Academy at Anderson Creek 1112 - 173 Scholar Drive, Spring Lake, 28390  
 Harnett County  
 Created: 4/5/2021

House Plan: Mixon III  
 Elevation: A  
 Stone/Brick Option: Option #1 see MSS  
 Foundation: Crawl  
 Foundation Finish: 3 Sides Parged  
 Garage Hand: Right  
 Garage: 2 Car Front  
 Garage Door: (2) 8x8  
 Front Porch: Concrete  
 Roof: Truss  
 Siding: Fiber Cement  
 Ceiling Height 1st Floor: 9'  
 Ceiling Height 2nd Floor: 9'  
 Door Frame Height 1st Floor: 83"  
 Door Frame Height 2nd Floor: 83"  
 Windows 1st Floor: 6/0 Front only, 5/0 side&rear  
 Windows 2nd Floor: 5/0

**MIXON III**  
 PLAN NAME  
**B-2287-45GR**  
 PLAN I.D.  
**1-28-21**  
 DATE

**A-2A**  
 SHEET

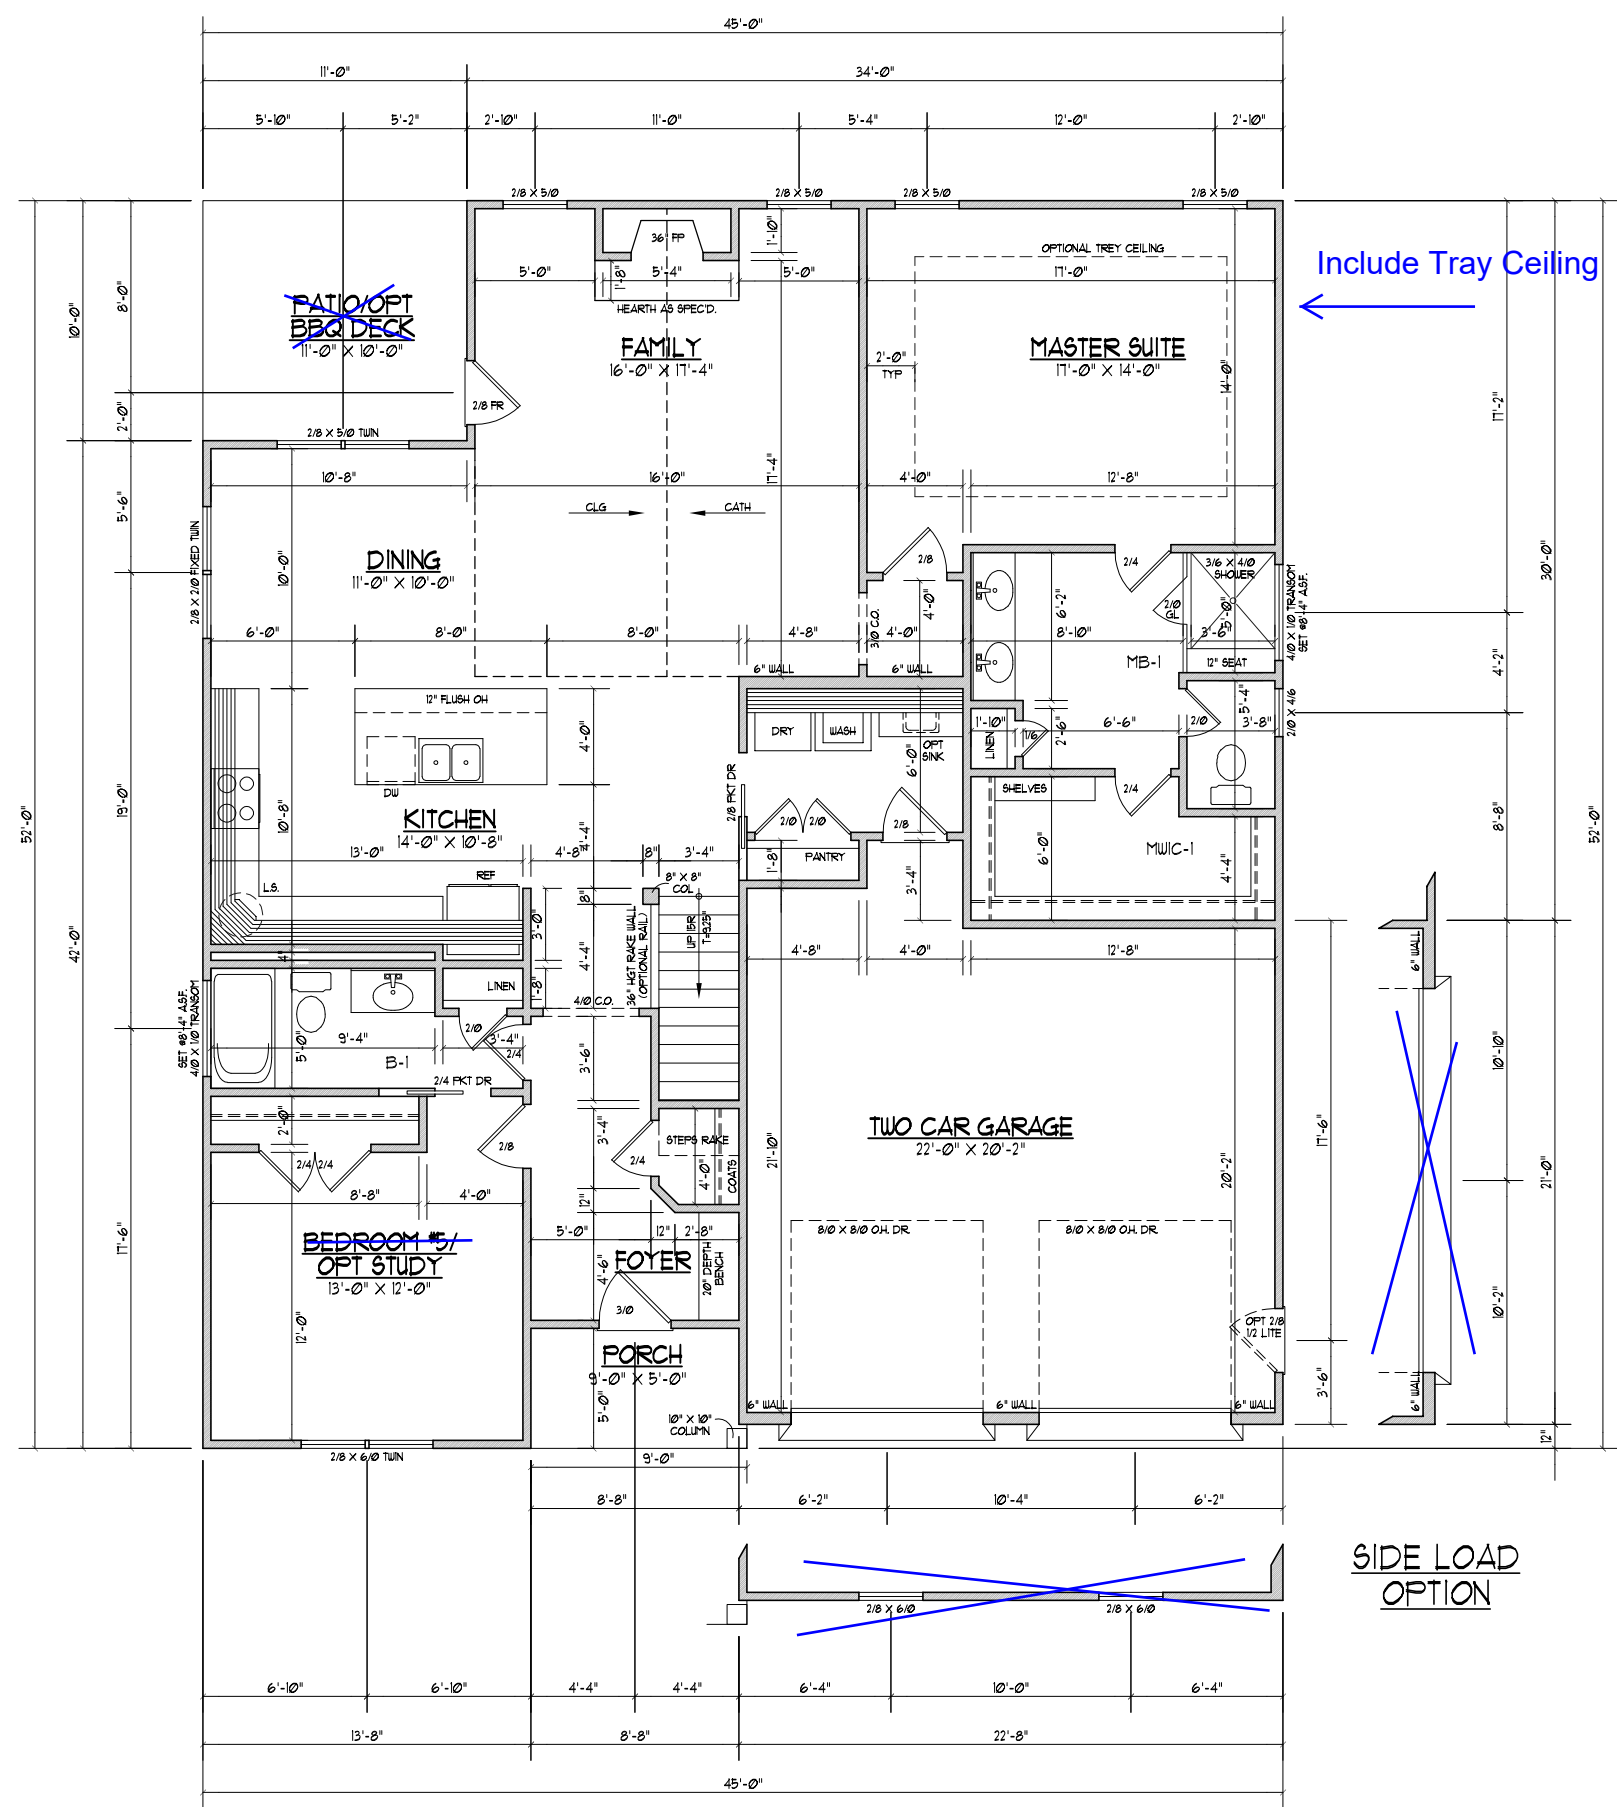
Include Screened Porch →

← Include Tray Ceiling

Study in Lieu of Bedroom #5 →

**A-3A**  
 SHEET

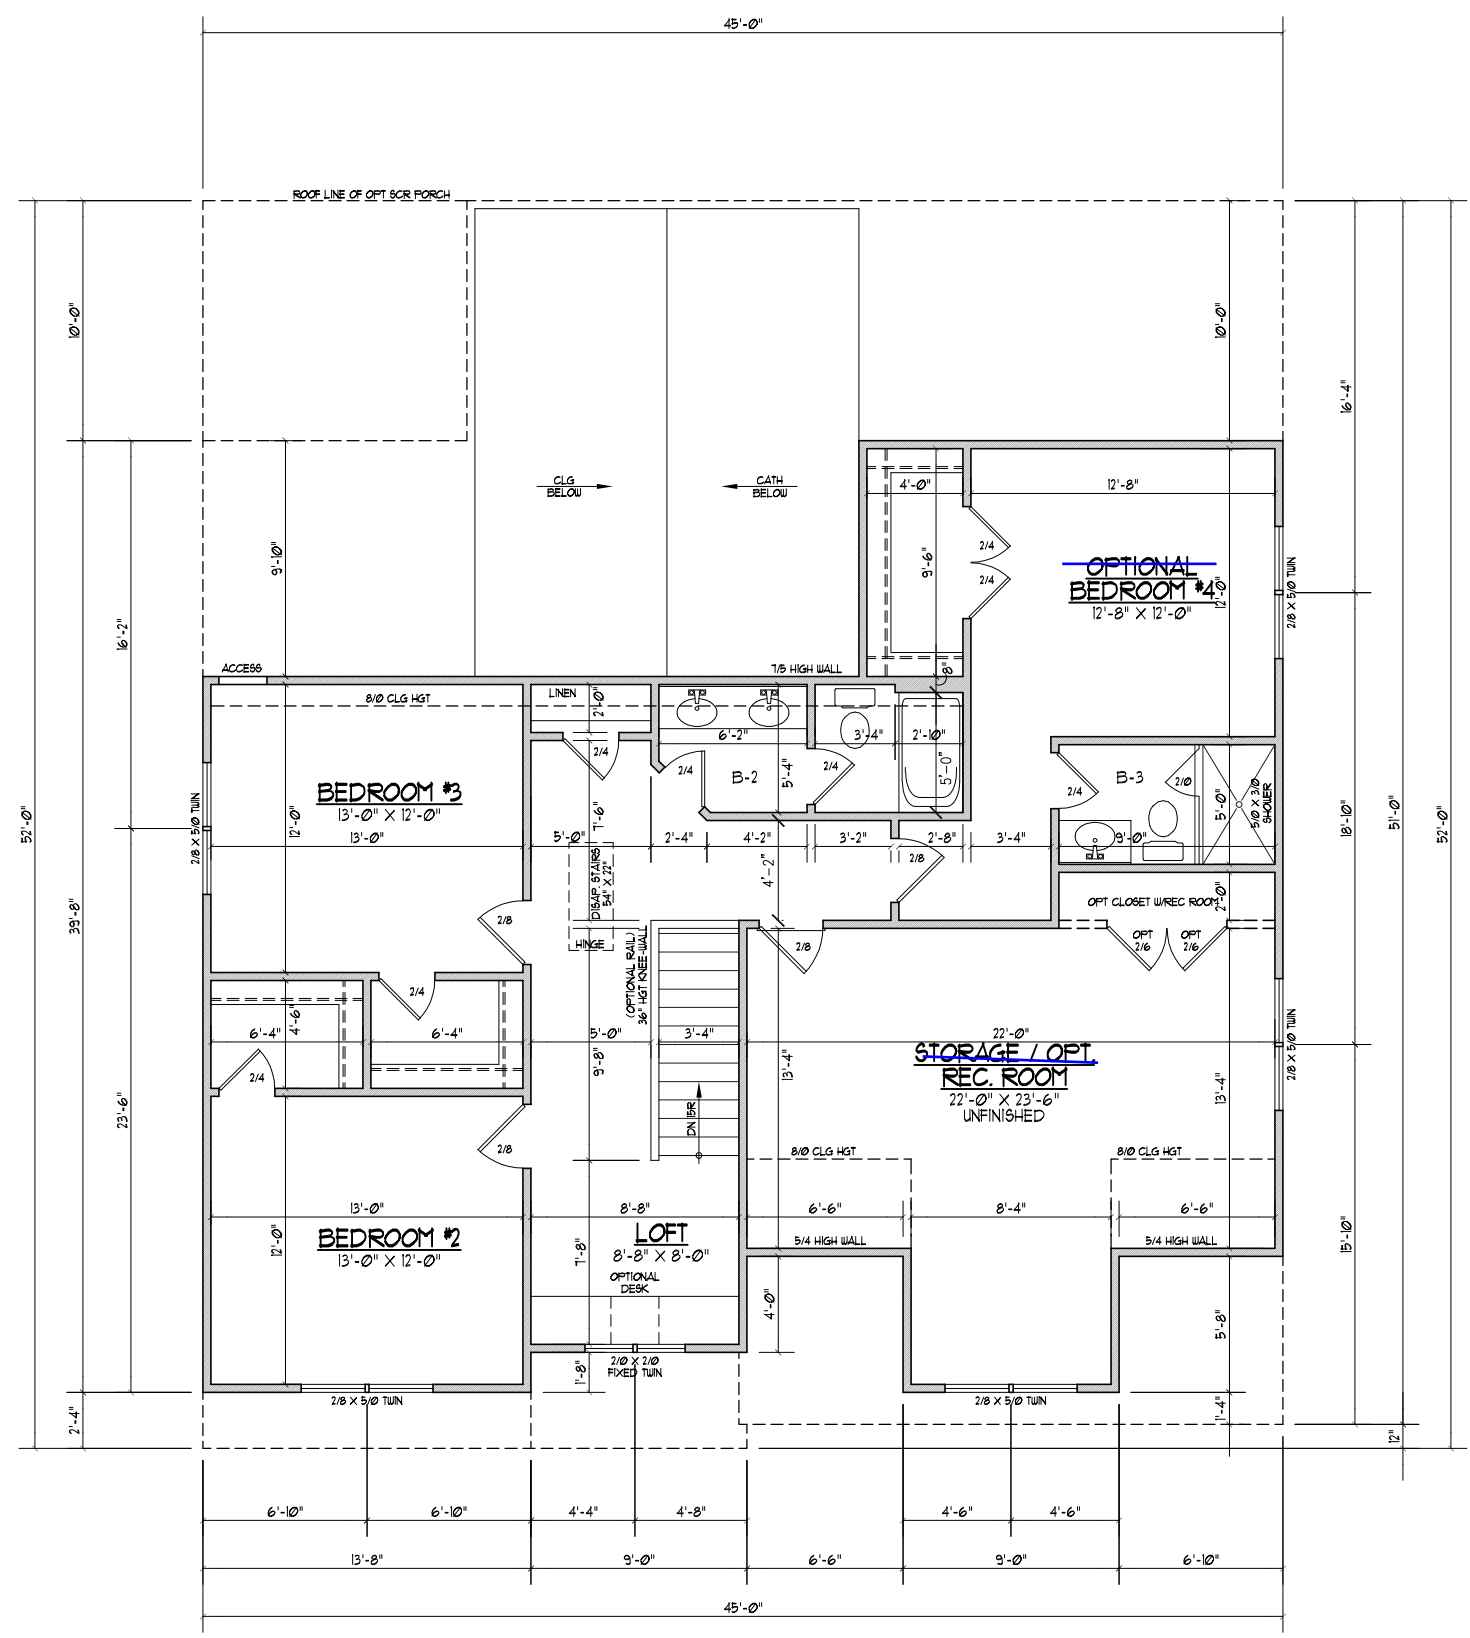
← Include Bedroom #4

← Include Rec Room and Closet

**E-1** SCREEN PORCH OPTION  
 SHEET

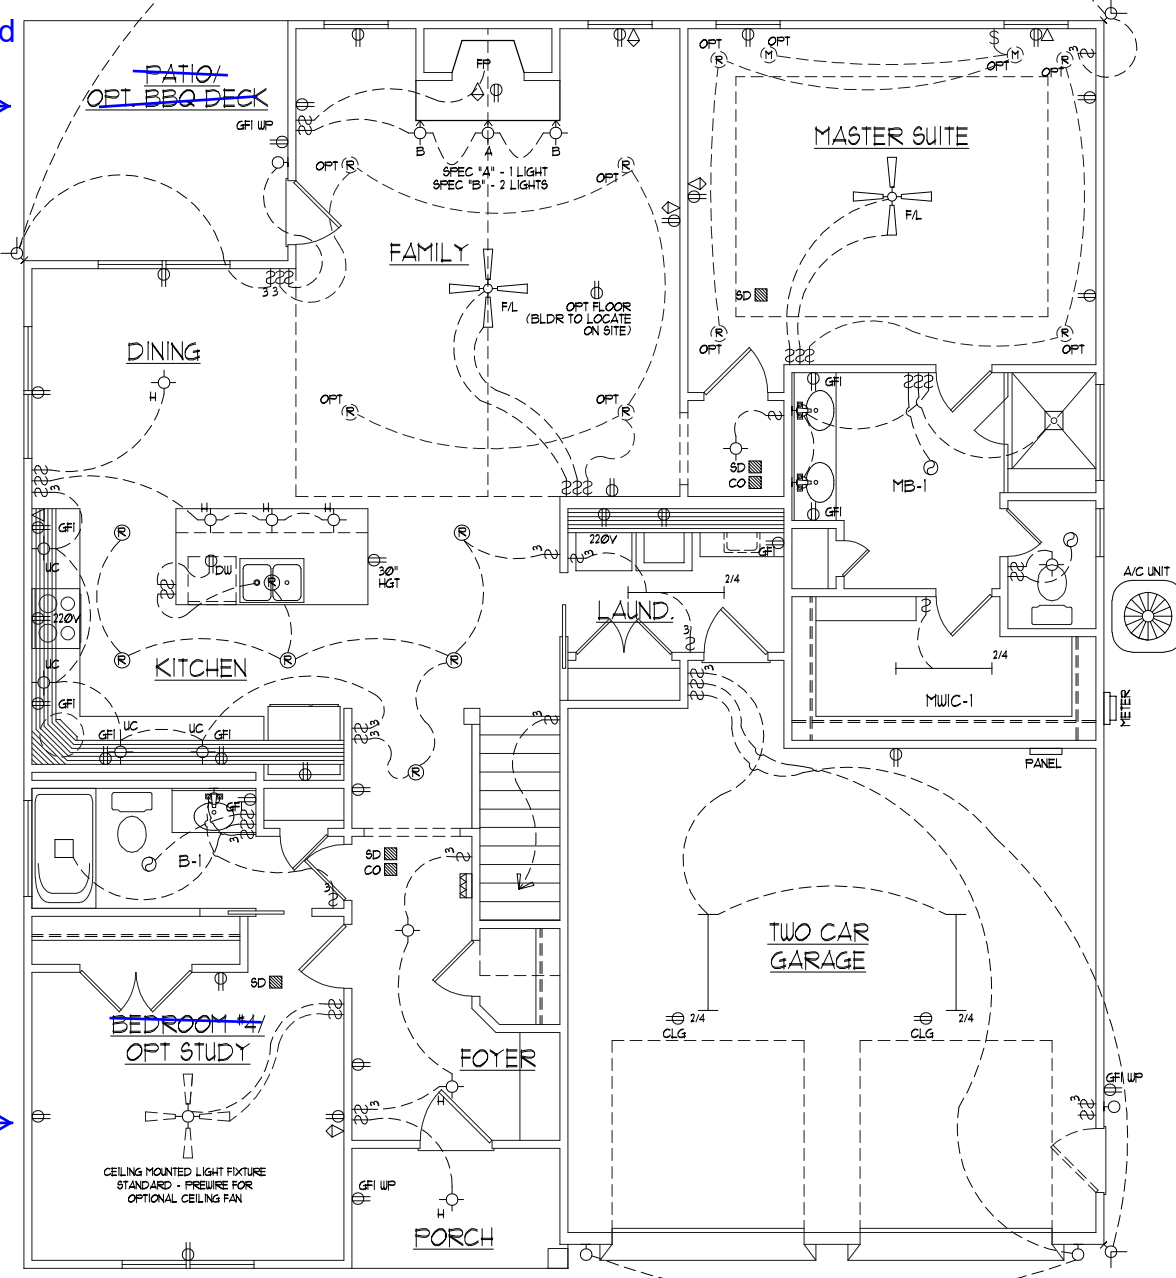
Include Screened Porch

Study in Lieu of Bedroom #5

SECOND FLOOR  
 ELECTRICAL LAYOUT  
 W/ BEDROOM #4 / BATH OPTION

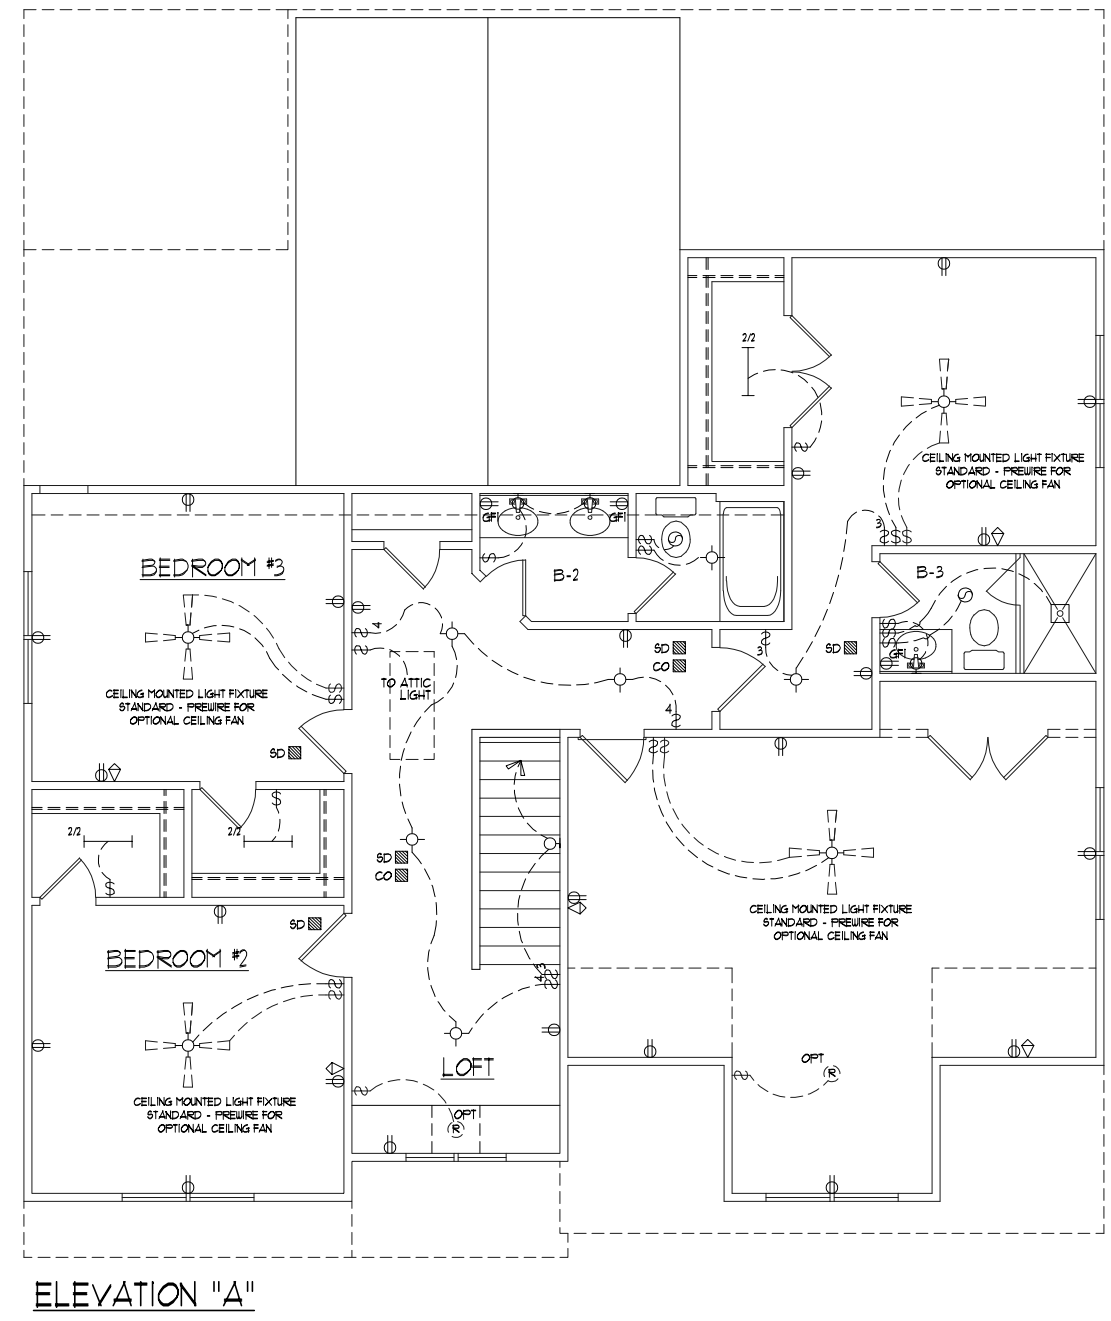
← Include Bedroom #4

← Include Rec Room and Closet

CRAWLSPACE FOUNDATION

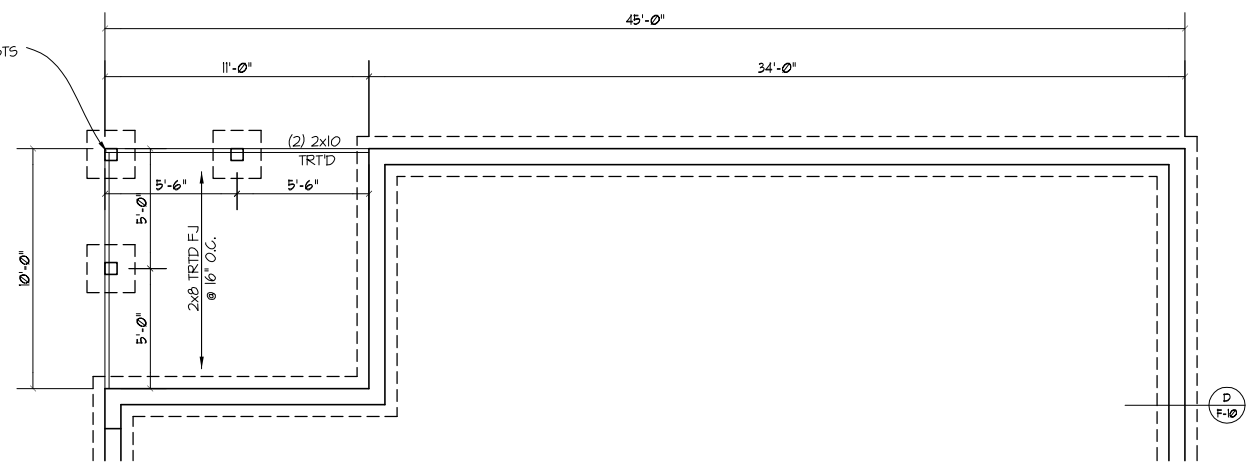
Include Screened Porch →

**S-2A**  
 SHEET

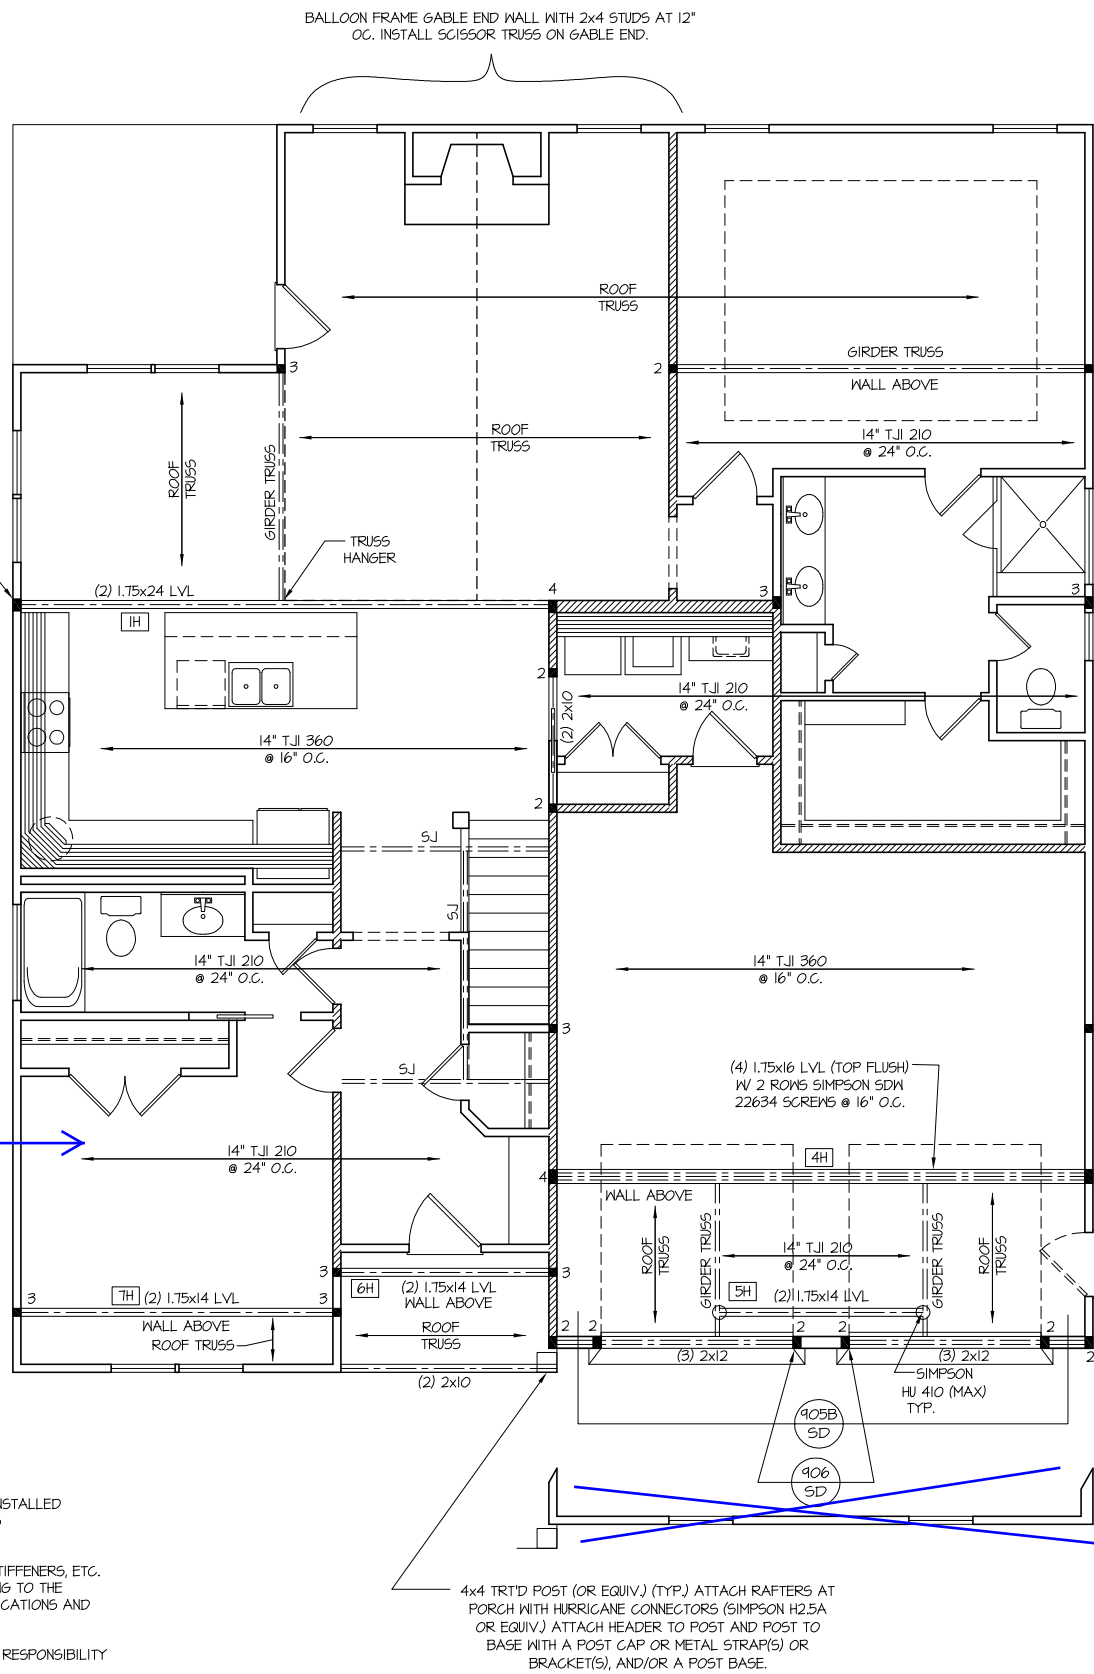
Study in Lieu of Bedroom #5

Include Tray Ceiling
